Ross Valley Flood Protection & Watershed Program

# Corte Madera Creek Flood Risk Management Project Draft EIS/EIR

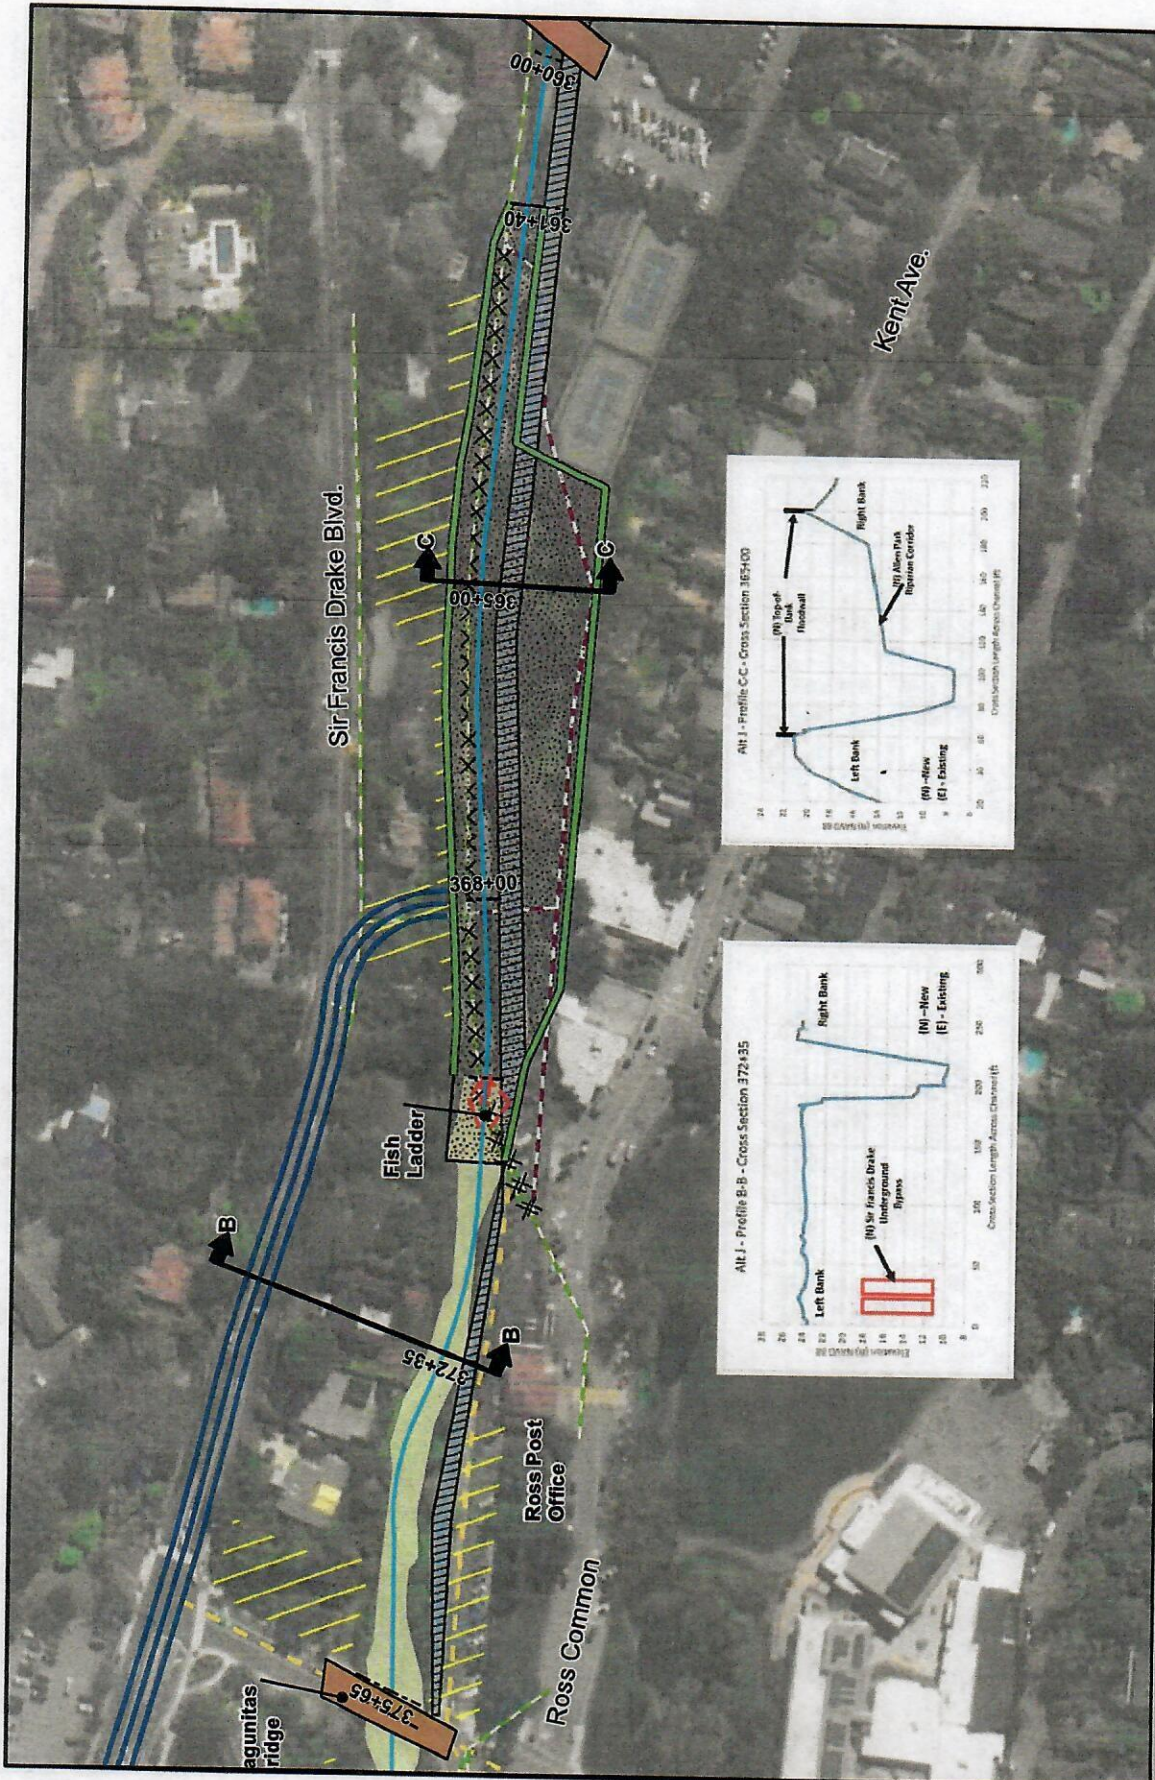
There are at least two creek crossings and three (under flood wall) crossings under flood walls proposed by Alt J. Cross sections at specific Station 368+00 and 361+40 indicates 16' deep creek bed, plus 3' clearance for sewer line. How does the required 19' affect function of the sewer pipes? How does this deep excavation add to as yet unquantified estimates for vegetation removal, stability, seepage, settlements yet unknown per Geotechnical Appendix N 5.1.1, 5.1.2, 5.1.3? What is the cost of excavation, demolition and relocation of the sewer lines, including laterals, in Units 4 and 3? **FIG 6.**

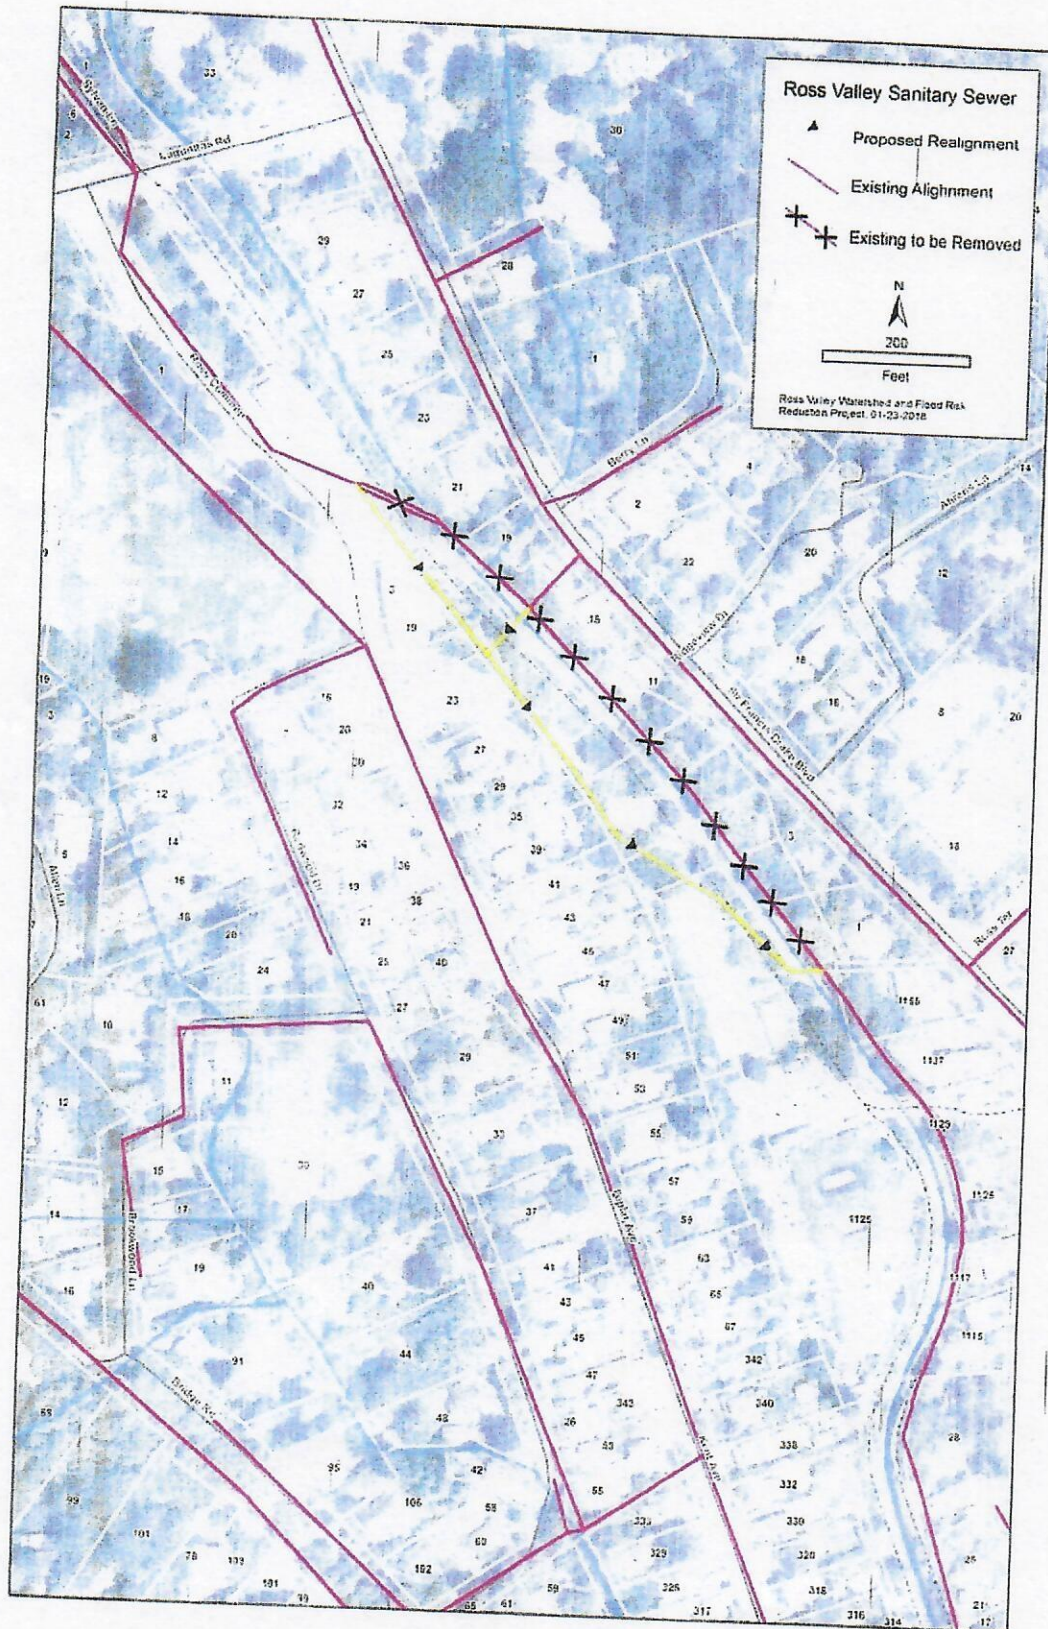
Several borings from a geotechnical investigation along the left bank encountered shallow bedrock. The use of a temporary shoring system will need to be evaluated as sheet piles may not be sufficient to excavate to the depths currently anticipated for the bypass. Additional geotechnical investigations will be needed to better understand the subsurface soil and rock characteristics along the bypass alignment. This could have significant cost impacts during Project construction.

**Concrete channel symposium 11/22/13**

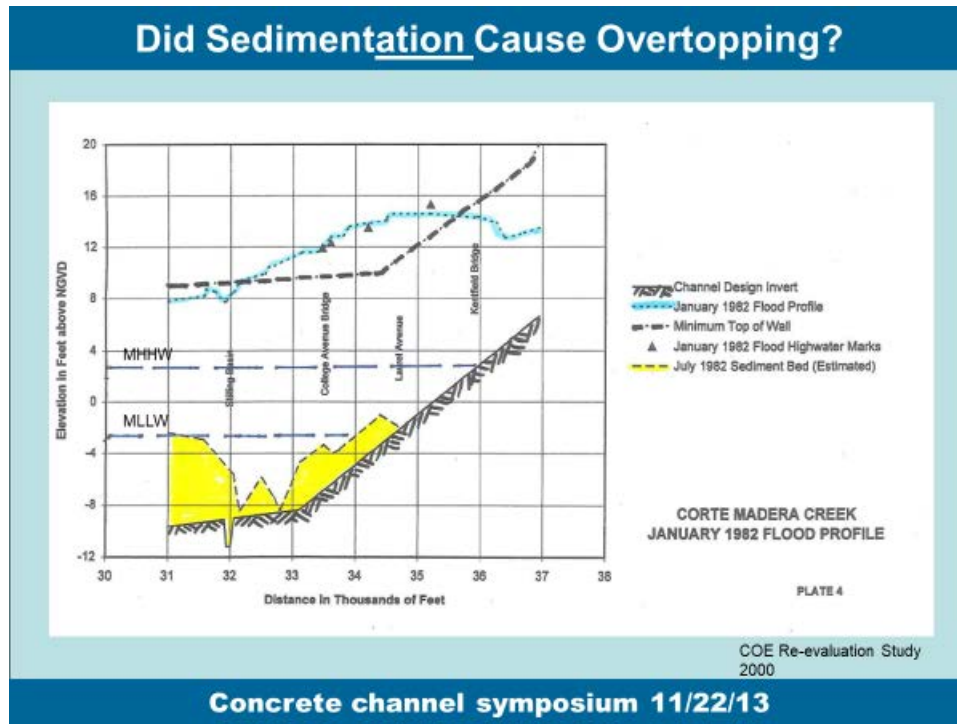
The influence of accumulated sedimentation, as opposed to the resistance caused by moving bedload sediment has been modelled and researched in prior studies of Corte Madera Creek and the similarly designed Mission Creek in Santa Barbara, including those conducted by the Corps of Engineers [R. Copeland August 2000. 'Corte Madera Creek Modified Unit 4 Sedimentation Study', US Army Corps of Engineers Waterways Experiment Station.].

The slide shown below of the water surface profile of the record 1982 flood event illustrates one such modelling study.
